INDEPENDENT ADVISORY PANEL FOR UNDERGROUND MINING

**DENDROBIUM COAL MINE
LONGWALL 18
SUBSIDENCE MANAGEMENT PLAN**

November 2020

Figure 1: Plan showing past and proposed mining at Dendrobium Mine, the defunct workings of Elouera Colliery and Lake Avon and the geological setting in and around the vicinity area of LW18

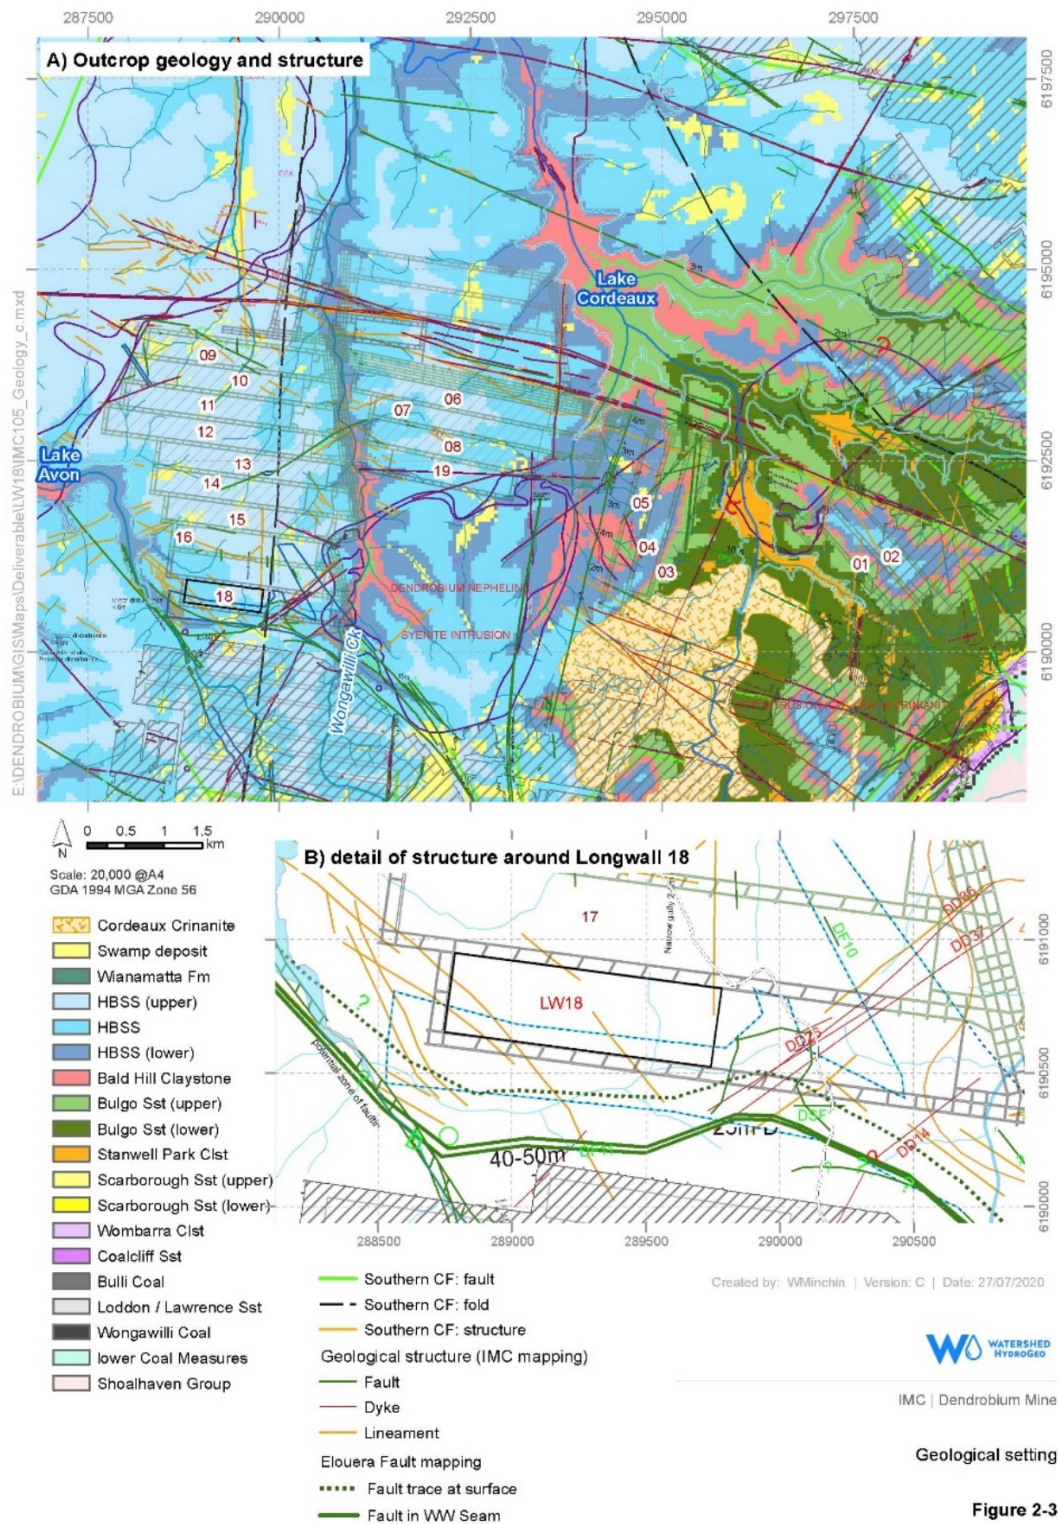
The SMP is based on LW18 having been shortened by some 800 m from originally planned (see Figure 1) and set back about 70 m from the fault zone.⁴ Subsidence predictions for the new layout have been updated in MSEC (2020) and the SMP has been subjected to a peer reviewed risk assessment (AXYS, 2020). The Panel is satisfied with these documents and does not consider that a critique of them is warranted to address the Department’s Scope of Works.

Figure 2: Elouera fault location

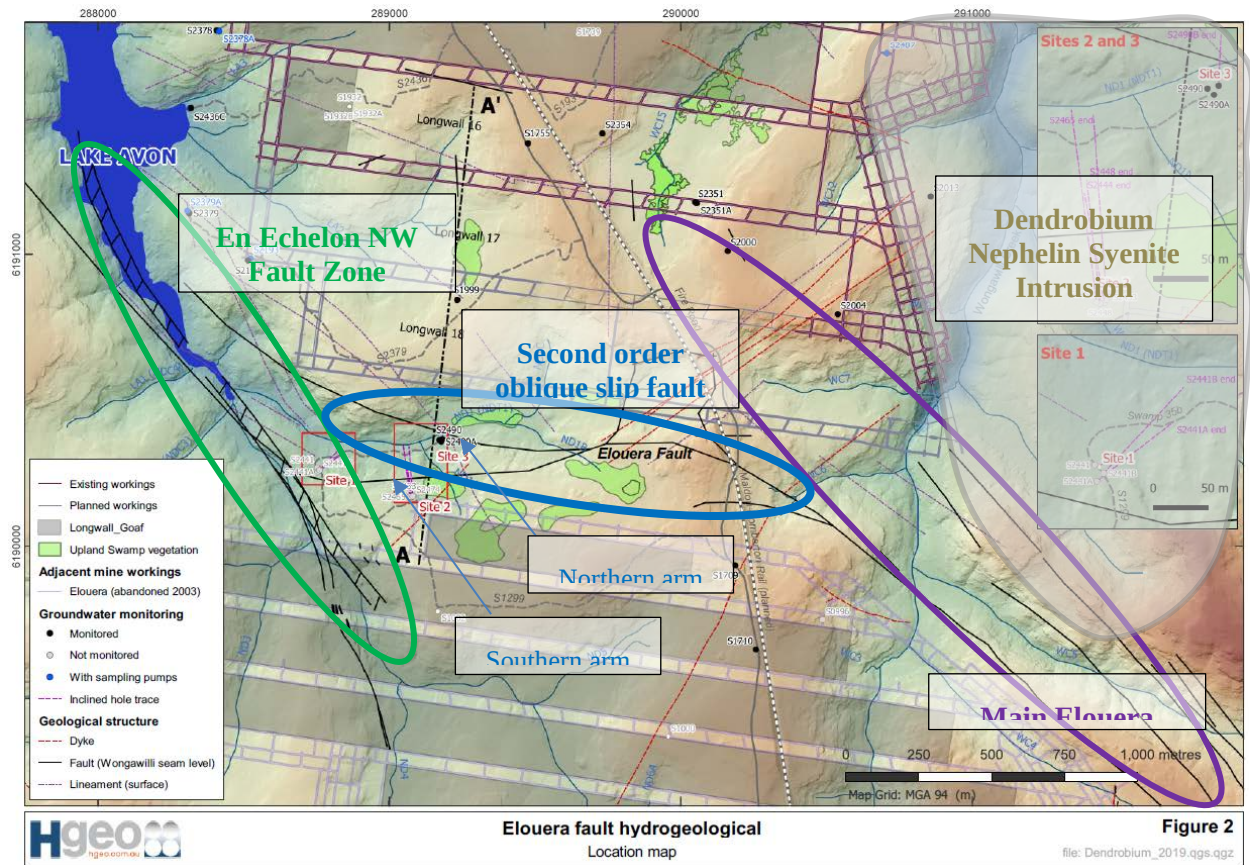
The Elouera Fault is located between Dendrobium Mining Area 3B (LW18) to the north, and the existing, flooded, Elouera Mine workings to the south. Figure 2 has been derived from a combination of two figures in existing reports, being: Figure 2 from HGEO (2020d), with annotations added to define the three key fault zones referenced as Figure 4 of HGEO (2020d).

Of note is the ‘box’ structure in the mid/eastern section of the original footprint of LW18, which is associated with a geologically complex zone. LW 18 has now been shortened to avoid this structurally complex zone.

Figure 3: Avon Reservoir loss estimates (Watershed 2020 (Watershed HydroGeo, 2020)).

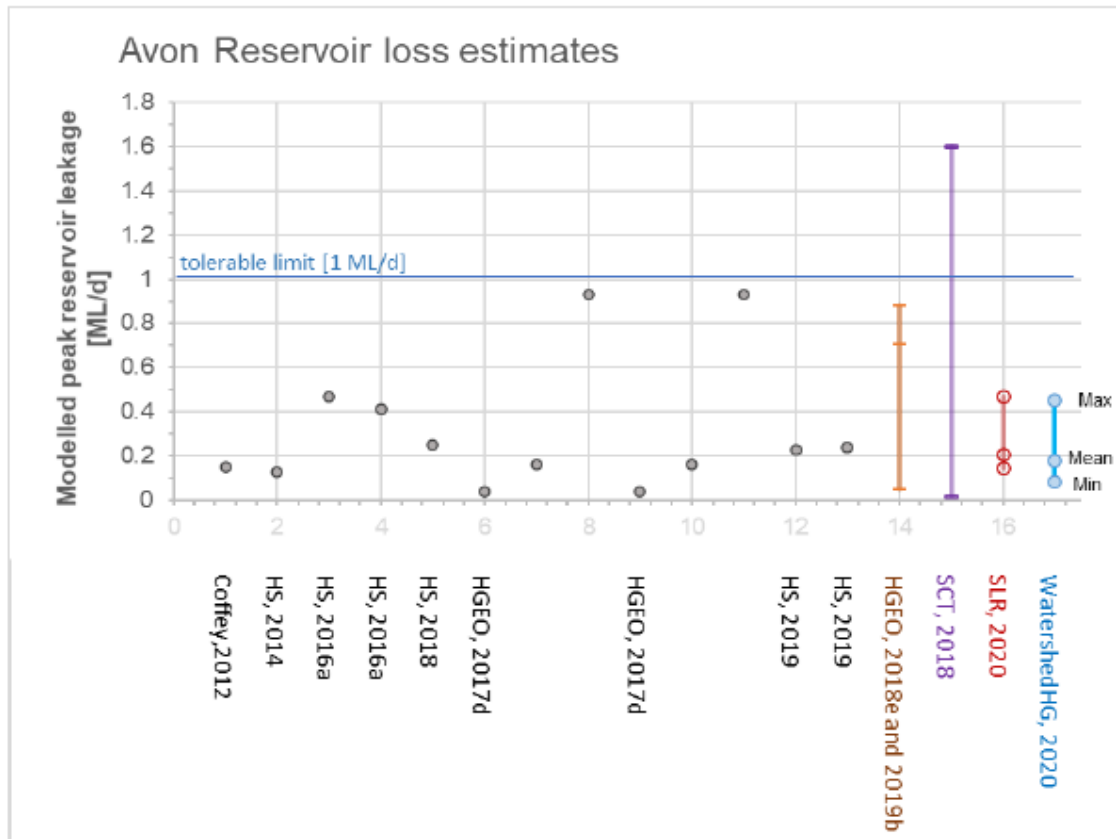
The leakage from Lake Avon as a result of mining at Dendrobium has been estimated and considered in various groundwater assessments, models and reports since 2012. Figure 3 is reproduced from Watershed HydroGeo (2020), to illustrate both the duration and number of studies that consider the leakage component from Lake Avon.

The current modelled leakage from Lake Avon as a result of all mining at Dendrobium Mine is estimated to be between 0.09 and 0.45 ML/day (Watershed HydroGeo, 2020) depending on which scenario is modelled. All scenarios fall within the prescribed tolerable limit as established by Dam Safety NSW of 1 ML/d with one exception being the range provided by (SCT, 2020). The higher end of this modelled range occurs for the higher ‘off goaf’ permeability scenario and not from scenarios that increase the permeability in the Elouera Fault (Watershed HydroGeo, 2020), suggesting the model results are not overly sensitive to fault permeability. The increase in leakage from Lake Avon due to LW18 is estimated to range between 0.01 and 0.13 ML/day.

Figure 4: Figure provided by S32 on 16/11/2020 in response to Panel query regarding the northern fault branch (DF11-N)

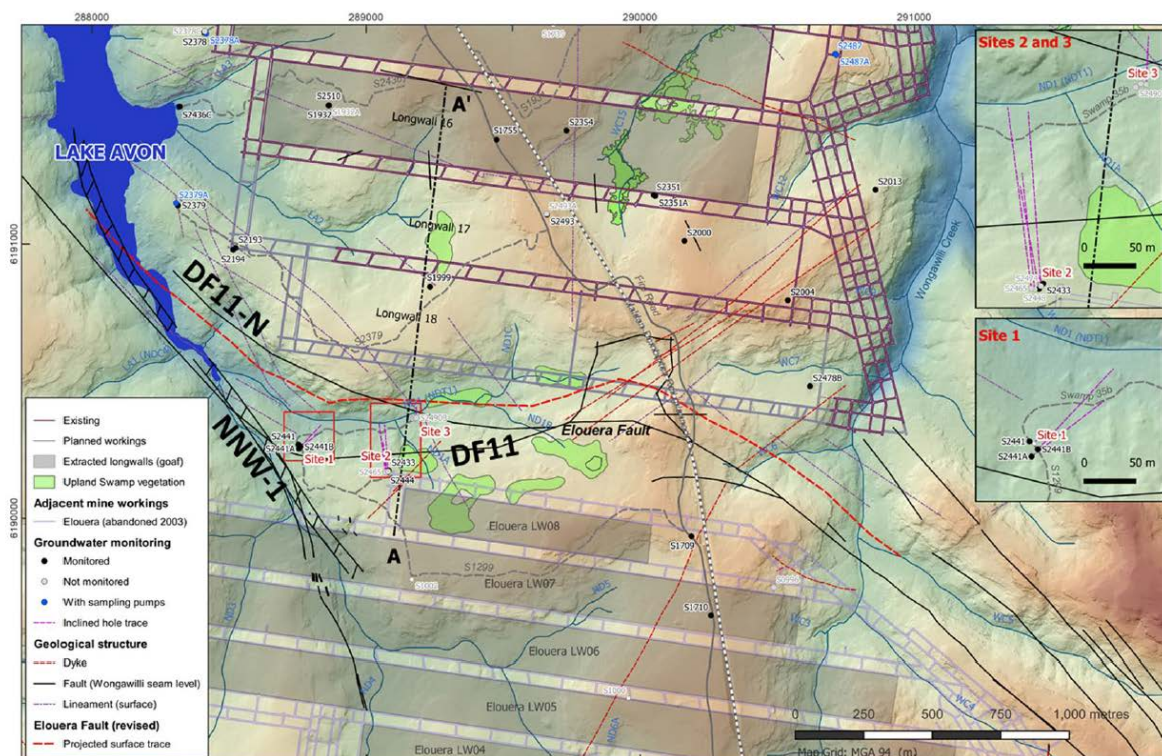
The Elouera Fault system includes branches to the south of LW18 as shown in Figure 4. The DF11 fault branch is considered by South32 to be most significant in terms of potential connectivity between Lake Avon and LW18. DF11 is 150 m from the LW18 footprint at its closest projected surface point (Table 2-3 of Watershed HydroGeo (2020)). Surface expressions of the fault have not been observed. The fault investigations conclude that, although the data show that in places the permeability of the fault zone is higher than in the surrounding hydrogeological units, the data indicate that the DF11 fault does not provide a conduit to groundwater flow.

Figure 7: Long-term (since 2013) increase in electrical conductivity at WC21 Pool.

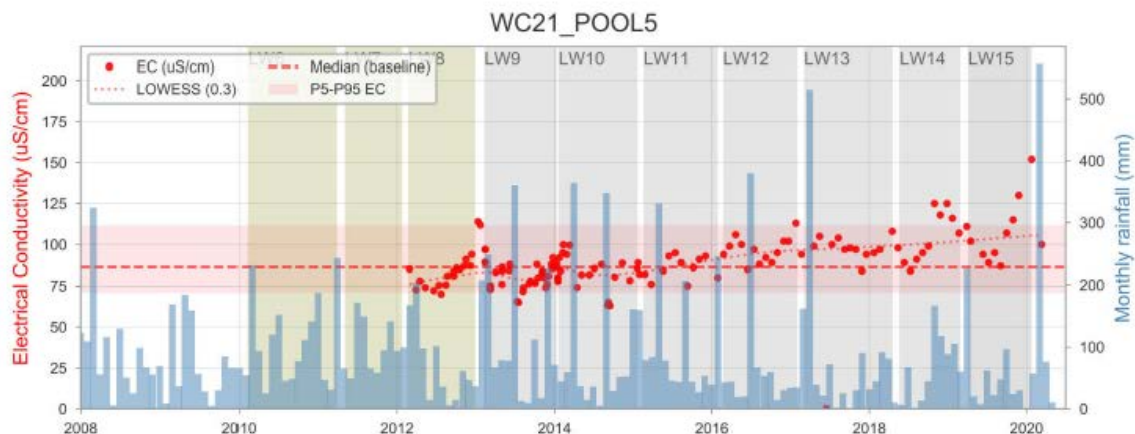
The water quality TARPs remain as in previous (2019) version of the WIMMCP. For the purpose of the LW18 SMP, the Panel has no objections to the TARPs or associated monitoring. However, going forward, the TARPs by themselves are not sufficient indicators of medium to long term trends in water quality. The TARPs are designed to identify and manage short-term anomalous extremes in water quality indicators (values greater than the 99.7 percentile). However, it is trends over periods of years

that pose the greatest risk to the water quality of the reservoirs. The issue with trends is illustrated in Figure 7, which shows the long-term (since 2013) increase in electrical conductivity at WC21 Pool5. In that case, and in general, the EOP reports include discussion of the trends and their potential significance, but there is no metric that allows trends to be easily analysed and recorded. A reporting requirement should be adopted that reports changes in trends in concentrations and also loads (flow x concentration). Consideration should also be given to the IEPMC (2019b) and IAPUM (2020) conclusions and recommendations regarding long-term, post-closure water quality risks.
